Docket No. 50-346

August 14, 1984

## SAFETY EVALUATION

This Safety Evaluation is written to justify that adequate cooling capacity exists for the Emergency Core Cooling System (ECCS) pump room, decay heat cooler from and H<sub>2</sub> dilution system blowers with the valves SW-86, SW-94, SW-102, SW-108, SW-116, SW-371 and SW-381 locked closed (see Fig. 9.1.-1 attached).

FIG. 1

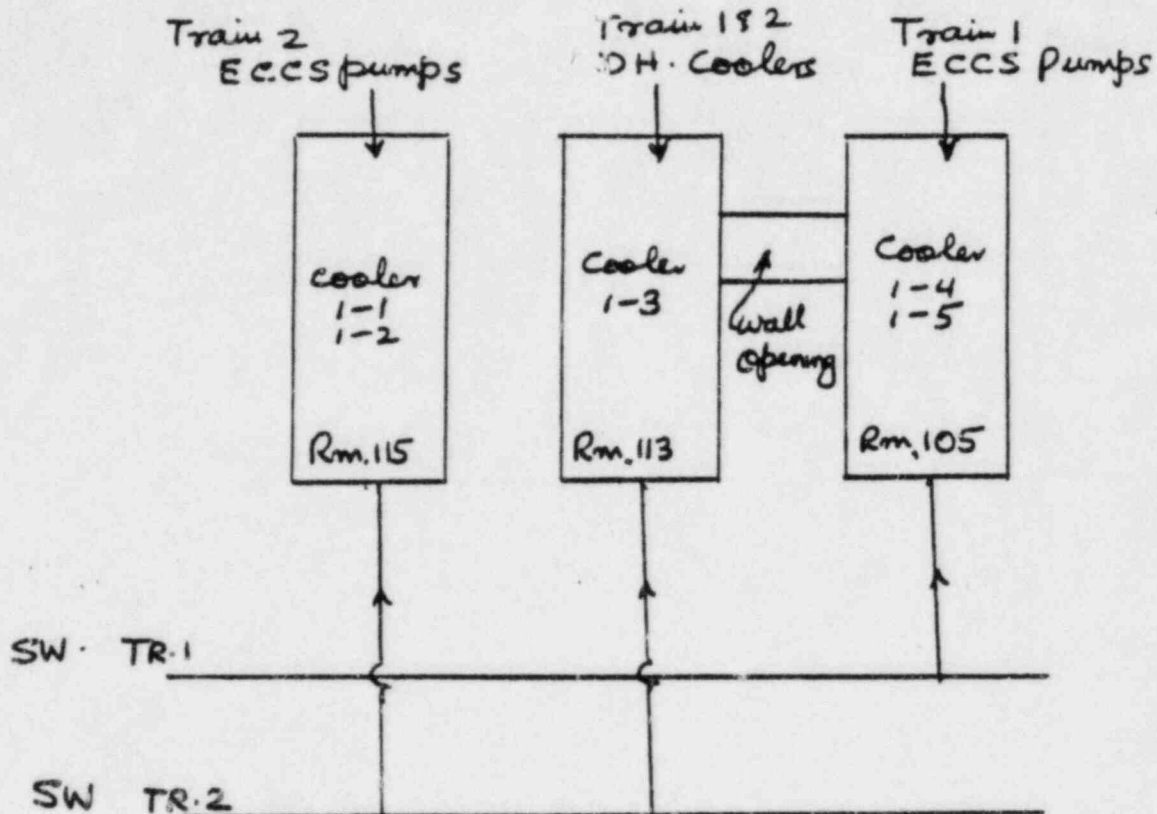
ECCS pump room coolers 1-1 and 1-2 are located in room 115 (ECCS pump room 2), coolers 1-4 and 1-5 are in room 105 (ECCS pump room 1) and the cooler 1-3 is located in room 113 (DH cooler room) (see Fig. 1 attached). There are at present two trains of service water that supply water to each of the above coolers. However, only one train of service water is required to serve each of these coolers.

If train 1 of service water which provides flow to ECCS pump room coolers 1-4 and 1-5 in room 105 fails, the redundant train 2 will provide flow to the ECCS pump room coolers 1-1 and 1-2 in room 115 and the decay heat cooler room cooler 1-3 in room 113. The operable train 2 of SW will provide adequate cooling capacity in ECCS pump room 115 and decay heat cooler room 113, and, as a result, train 2 ECCS pumps will remain operable.

If train 2 of service water which provides flow to the ECCS pump room coolers 1-1 and 1-2 in room 115 and decay heat cooler 1-3 in room 113 fails, the redundant train 1 will provide flow to ECCS pump room coolers 1-4 and 1-5 in room 105. We have calculated that two coolers in ECCS pump room 105 will have adequate capacity to remove the heat loads in rooms 105 and 113, and will maintain these room design temperatures equal to or less than 122°F in accident condition. Therefore, the operable train 1 of SW will provide adequate cooling capacity in ECCS pump room 105 and decay heat cooler room 113, and, as a result, train 1 ECCS pumps will remain operable.

Pursuant to the above it is concluded that changing the valves' position in the proposed change from locked open to locked close and eliminating the requirements for reverse flow testing of the associated check valves will not degrade the SW system's redundancy to meet the single failure criteria, and the two SW trains will be properly isolated from each other. As a result, there is no unreviewed safety question involved.
